August 17, 2012 (Revised September 20, 2012)

Subject: Clifton Heights Storage Basin
Minor Project Modification
IOAP Project No. L_MU_MF_154_M_09B_B_A_8
DOJ Case No. 90-5-1-1-08254

MSD is providing advanced notification of a proposed minor project modification to the Clifton Heights Storage Basin project (IOAP Project No. L_MU_MF_154_M_09B_B_A_8). This modification is part of an overall adaptive management review of the approved 2009 IOAP that will be documented in the proposed 2012 IOAP Modification to be formally submitted in 2013. No action is requested at this time.

CSO LTCP Project Fact Sheet

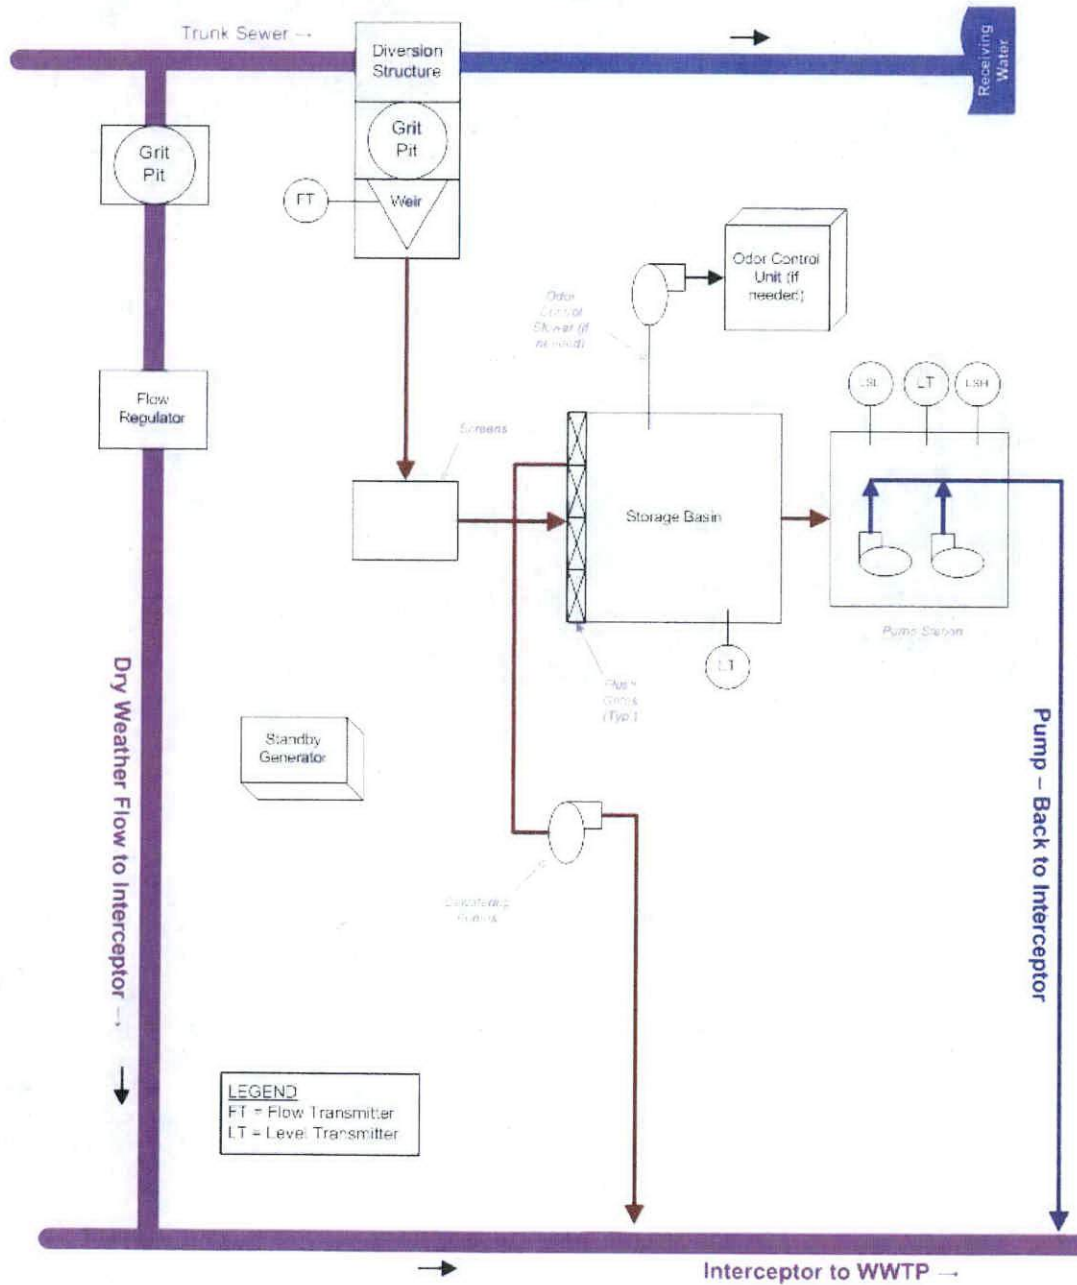
MSD proposes to change the Clifton Heights Storage Basin solution from a 6.55 MG basin to a 4.28 MG basin, and revise the level of control from eight overflows per typical year to four overflows per typical year.

Based on the results of the re-calibration, a level of control analysis was conducted on the Clifton Heights Storage Basin. The level of control analysis showed that the basin size of 4.28 MG would meet a level of control of four overflows per year and provide the highest benefit/cost ratio. Therefore, MSD proposes to change the Clifton Heights Storage Basin solution from a 6.55 MG basin to a 4.28 MG basin. These improvements will maintain the same completion date of December 31, 2018, as the original solution.

Project Description: This project includes a 6.55 MG underground covered storage basin for CSO132, 154 and 167 to reduced overflows to reduce overflows to eight overflows per year. The facility will require a 6.55 MGD PS to return the stored flow back to the interceptor.
